Groundwater Transfer Review Summary Form

Transfer/PA # I- <u>14518</u>
GW Reviewer <u>Stacey Garrison</u> Date Review Completed: <u>12/202024</u>
Summary of Same Source Review:
☐ The proposed change in point of appropriation is not within the same aquifer as per OAR 690-380-2110(2).
Summary of Water Level Decline Condition Review:
☐ Water levels at the original point(s) of appropriation have exceeded the allowed decline threshold defined by conditions in the originating water right.
Summary of Injury Review:
☐ The proposed transfer will result in another, existing water right not receiving previously available water to which it is legally entitled or result in significant interference with a surface water source as pe 690-380-0100(3).
Summary of GW-SW Transfer Similarity Review:
$\hfill\Box$ The proposed SW-GW transfer doesn't meet the definition of "similarly" as per OAR 690-380-2130.
This is only a summary. Documentation is attached and should be read thoroughly to understand the

Transfer Application: T- 14518

<u>Map</u>

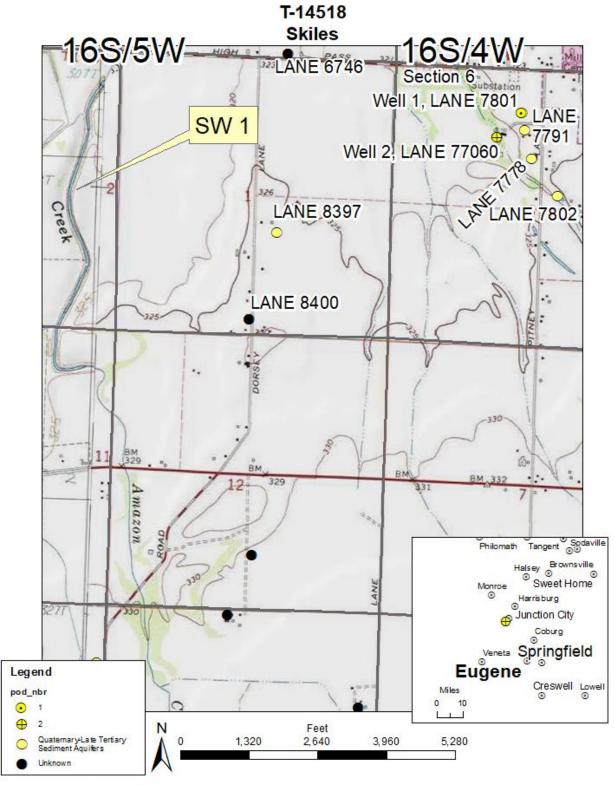
5.	a) Will this proposed change, at its maximum allowed rate of use, likely result in an increase in interference with another ground water right ?
	☐ Yes ☐ No Comments: <u>The proposed APOA/Well 2 (LANE 77060) is further from</u>
	the closest groundwater user, LANE 7791, than the authorized POA/Well 1 (LANE 7801). The increased distance is anticipated to reduce interference with other groundwater users.

6.	a) Will this proposed change, at its maximum allowed rate of use, likely result in an increase in interference with another surface water source ?
	Yes No Comments: The proposed APOA/Well 2 (LANE 77060) is closer to the
	nearest surface water source, SW 1 (Amazon Creek), than the authorized POA/Well 1 (LANE 7801). The decreased distance is anticipated to increase interference with SW 1 (Amazon Creek).

b) If yes, at its maximum allowed rate of use, what is the expected change in degree of interference with any surface water sources resulting from the proposed change?
	Stream: Amazon Creek Minimal Significant
	Provide context for minimal/significant impact: The reduced distance is relatively small compared to the overall distance: proposed APOA/Well 2 (LANE 77060) and authorized POA/Well 1 (LANE 7801) are 7,490 ft and 7,845 ft east of SW 1 (Amazon Creek), respectively, with a decreased distance of 355 ft.
